UNITED STATES PATENT AND TRADEMARK OFFICE

APPLICATION NO.	FILING DATE	FIRST NAMED INVENTOR	ATTORNEY DOCKET NO.	CONFIRMATION NO.
09/823,181	03/30/2001	Jingyue Ju	0575/62948/JPW/ADM/BJA	9161

Office Action Summary	Application No. 09/823,181	Applicant(s) JU ET AL.	
	Examiner Bradley L. Sisson	Art Unit 1634

DETAILED ACTION

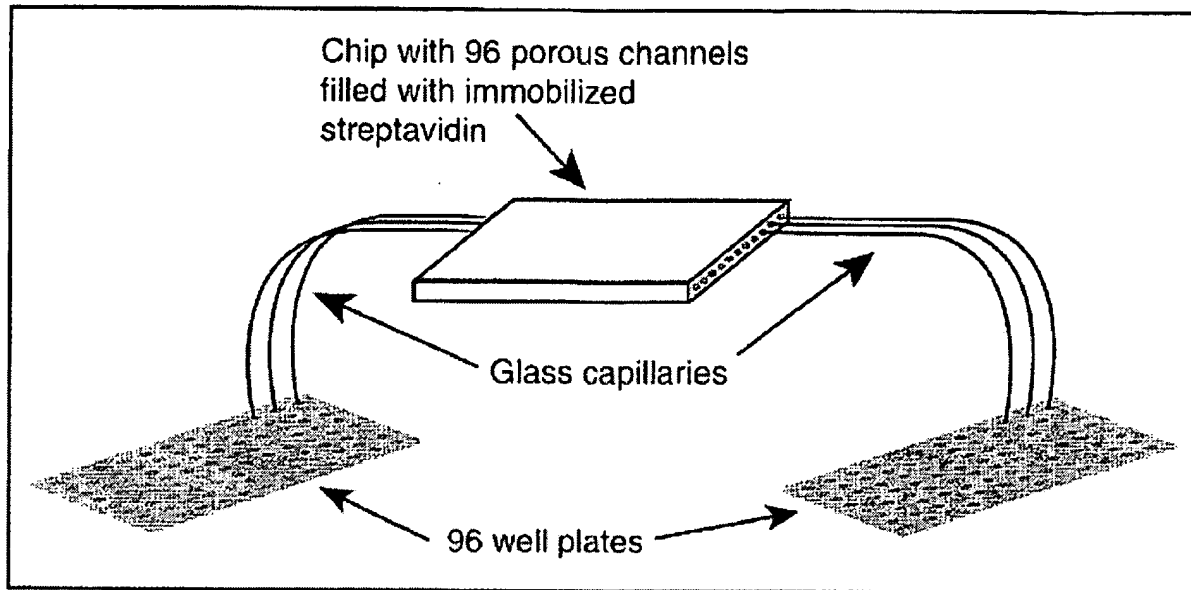
9. As noted above, the claimed method has been interpreted as comprising a plurality of wells connected via a channel. A review of the disclosure reveals a description via Fig. 12, of two 96-well plates that are connected via glass capillary tubes to corresponding single channels in a chip.

It is noted with particularity that the device described lacks any means for applying pressure such that any one, much less 96 different samples could be passed through the coated channels in one direction, much less back-and-forth, thereby permitting/enabling the binding of the DNA sequencing fragments. While the claims have been amended so to recite that there are "wells" located at either end of the glass capillaries, the specification has not been found to support a broader application of where the wells are the ends of the capillaries are anything other than a 96-well plate. For convenience, the relevant portions of page 48 are reproduced below.

Accordingly, the broader application of the term "wells" to include wells not of a 96-well plate is deemed to constitute new matter.
